IN RE:)	
)	
Bluebird Village Community Housing Project)	KETCHUM PLANNING & ZONING COMMISSION
Design Review)	FINDINGS OF FACT, CONCLUSIONS OF LAW, AND
Date: August 24, 2021)	DECISION
)	
Application File Number: P21-063)

PROJECT: Bluebird Village Community Housing Project

APPLICATION TYPE: Design Review

FILE NUMBER: P21-063

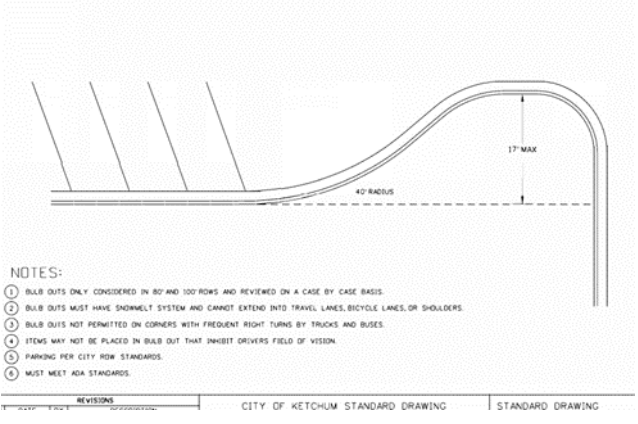
Ketchum Municipal Code §17.96.070.C2 requires all roof- and ground-mounted mechanical equipment to be fully screened from public view. The project plans show an existing transformer located within the Idaho Power easement located at the southwest corner of the parking lot parcel that is proposed to remain in its existing location. Building B is proposed to encroach over the Idaho Power easement (Instrument No. 613194) located at the northeast corner of the parking lot parcel. This easement contains an existing transformer that will need to be removed and relocated. The applicant will coordinate with the City and Idaho Power to determine the appropriate location for the relocated transformer and sufficient screening that complies with both Design Review standards and Idaho Power's clearance requirements for the development's electrical infrastructure. The applicant will be required to provide the City with written confirmation that Idaho Power consents to Building B's encroachment over the easement area at the northeast corner of the parking lot parcel prior to issuance of a Building Permit for the project.

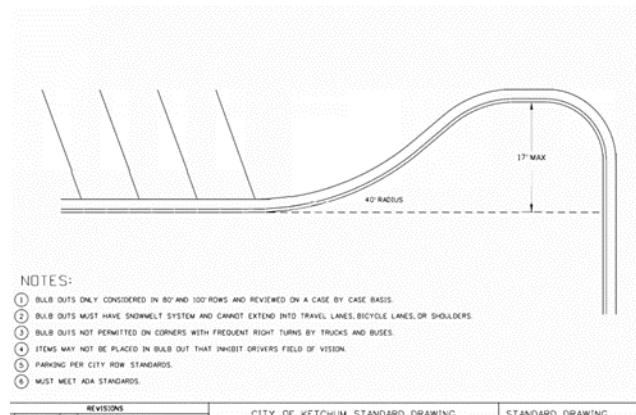
- An approved access roadway per 2018 International Fire Code Appendix D (www.ketchumfire.org) shall be installed prior to any combustible construction on the site. The road shall be a minimum of twenty (20) feet in width and capable of supporting an imposed load of at least 75,000 pounds. The road must be an all-weather driving surface maintained free, clear, and unobstructed at all times. Grades shall not exceed 7%. Dead end access roadways exceeding 150 feet in length shall be provided with an approved turnaround. Gates, if installed, are required to be siren activated for emergency vehicle access. Where the vertical distance between the grade plane and the highest roof surface exceeds 30 feet, approved aerial fire apparatus access roads shall be provided. Aerial fire apparatus access roads shall have a minimum

unobstructed width of 26 feet, exclusive of shoulders, in the immediate vicinity of the building or portion thereof.
